HISTORIC AND DESIGN REVIEW COMMISSION

HDRC CASE NO: 2021-318
ADDRESS: 220 N MESQUITE ST
LEGAL DESCRIPTION: NCB 583 BLK 8 LOT W 66.11 FT OF 10
ZONING: RM-4, H
CITY COUNCIL DIST.: 2
DISTRICT: Dignowity Hill Historic District
APPLICANT: Brad Clawson/Elise Construction
OWNER: MACKMOORE GROUP LLC
TYPE OF WORK: Window replacement, fenestration modifications
APPLICATION RECEIVED: June 24, 2021
60-DAY REVIEW: Not applicable due to City Council Emergency Orders
CASE MANAGER: Edward Hall

Window Replacement Exhibit

220 N. Mesquite St., San Antonio, TX 78202

A-105

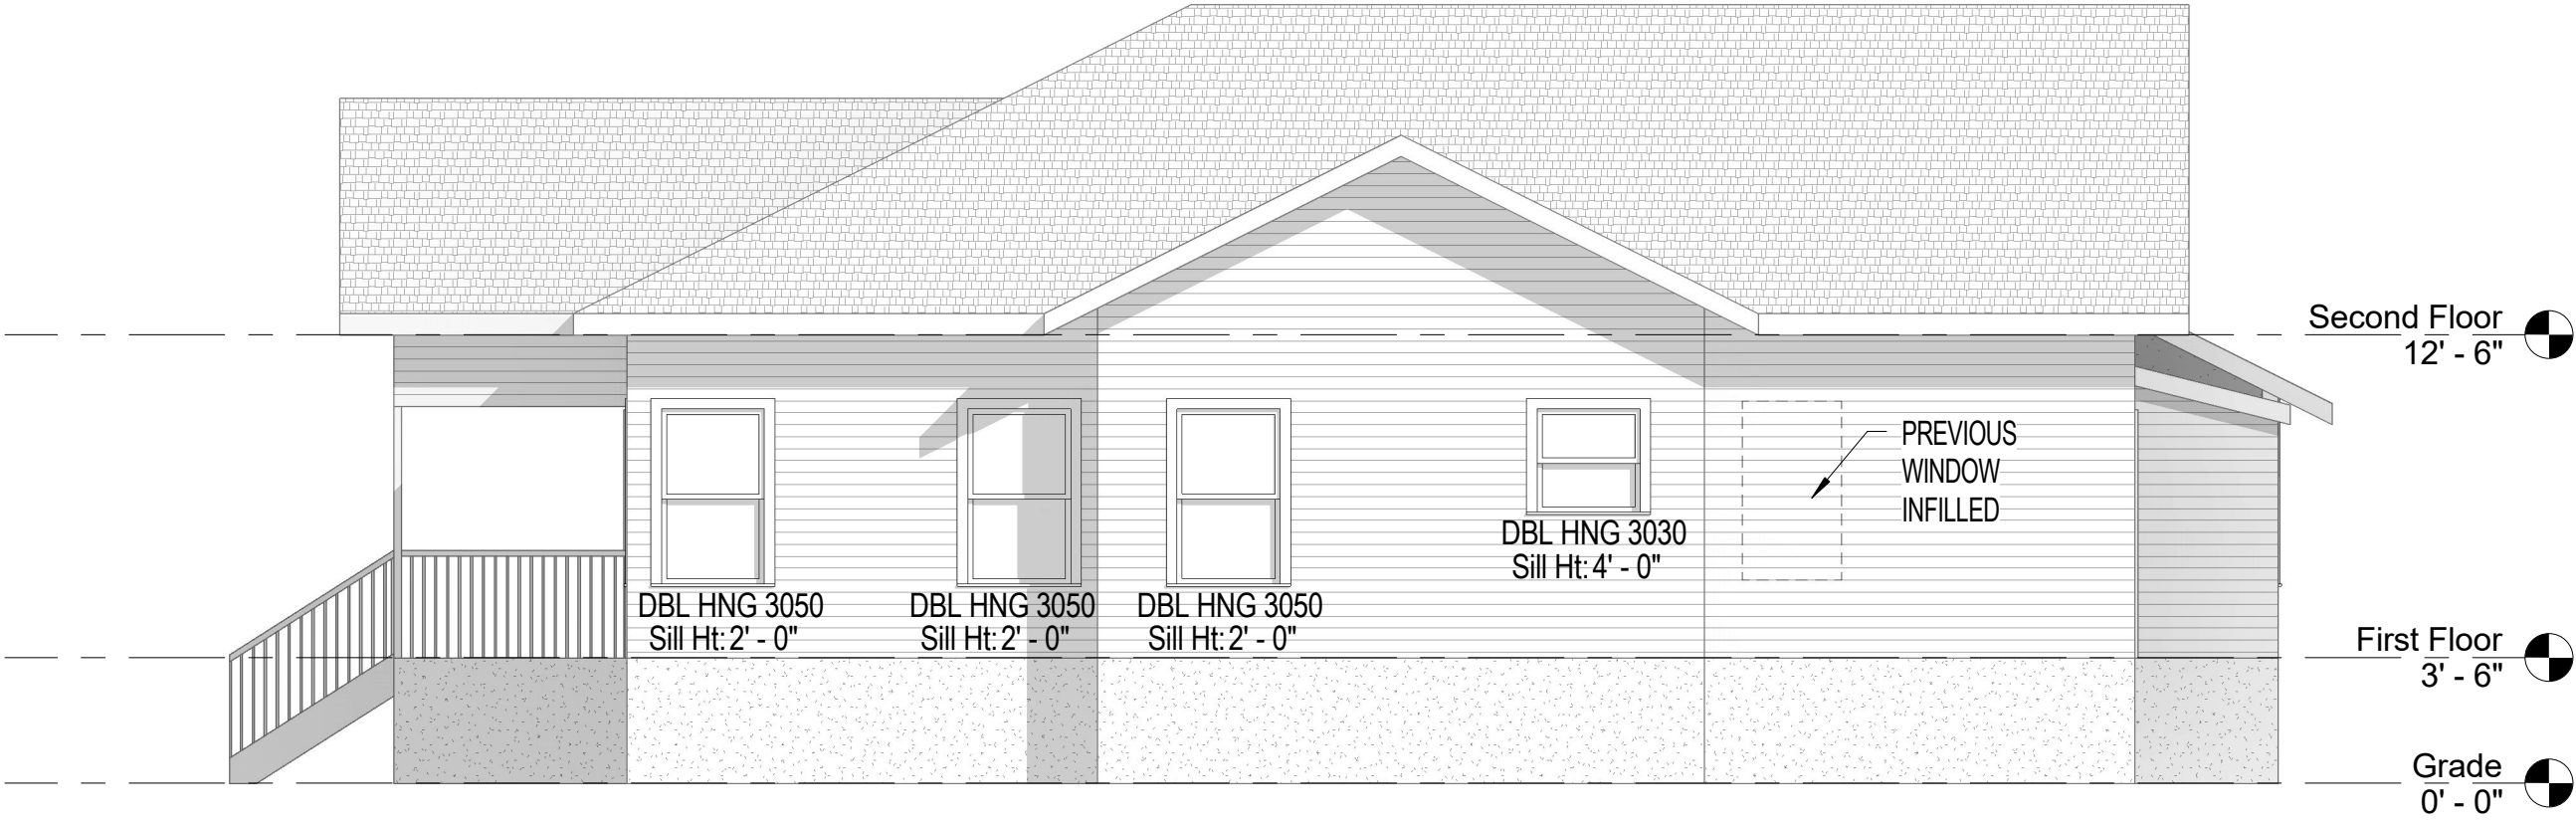
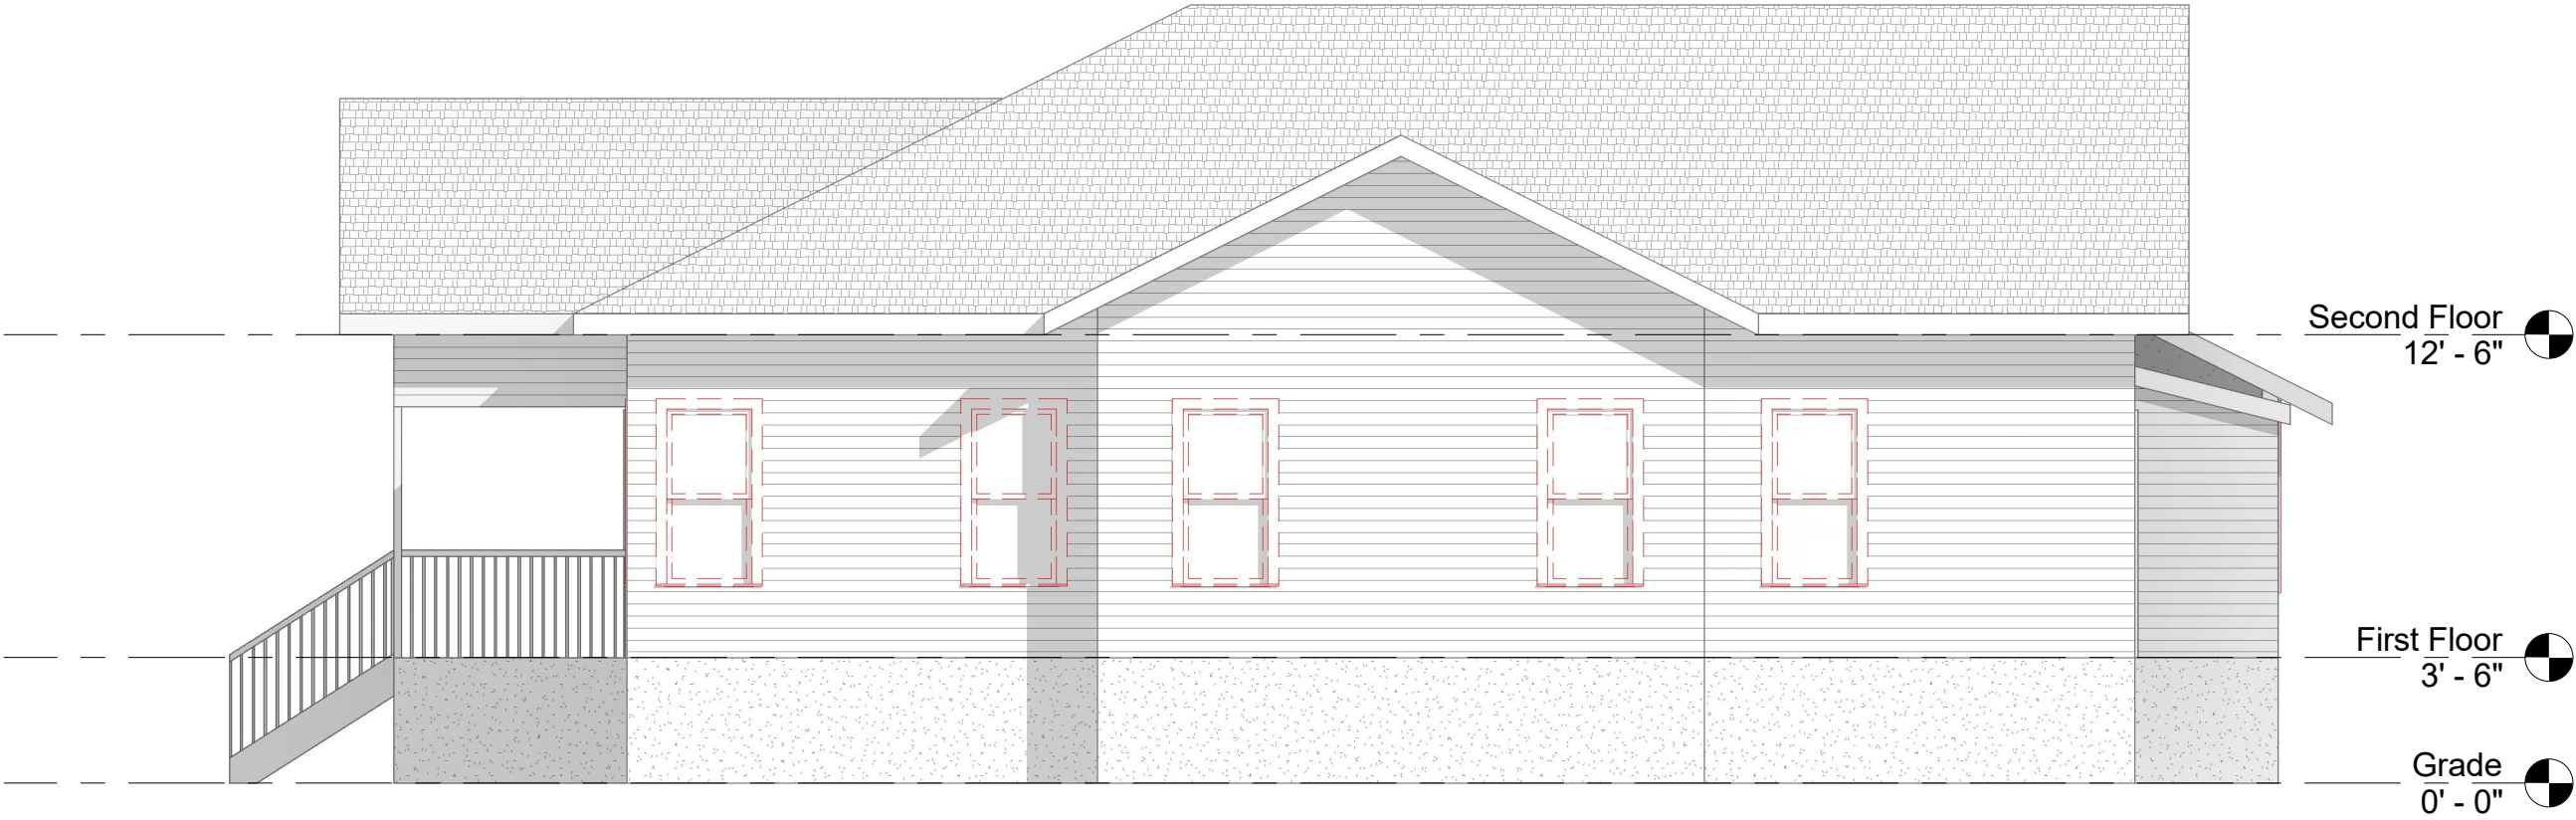
- c. **FENESTRATION MODIFICATIONS** – The applicant has proposed to remove two, existing window openings, one on the north façade and one on the south. Per the Guidelines for Exterior Maintenance and Alterations, 6.A.i., historic window and door openings should be preserved. Staff finds the proposed fenestration modifications to be inappropriate and inconsistent with the Guidelines.

1. Staff recommends approval of item #1, front façade modifications based on finding b with the following stipulations:
 - i. That the proposed window openings feature widths, and head and sill heights that are consistent with those found historically on the historic structure.
2. Staff does not recommend approval of item #2, fenestration modifications based on finding c. Staff recommends that all original window openings remain as they currently exist.
3. Staff recommends approval of item #3, aluminum window replacement with new aluminum windows based on finding d, with the stipulation that the proposed replacement windows be consistent with staff's standard specifications for windows.
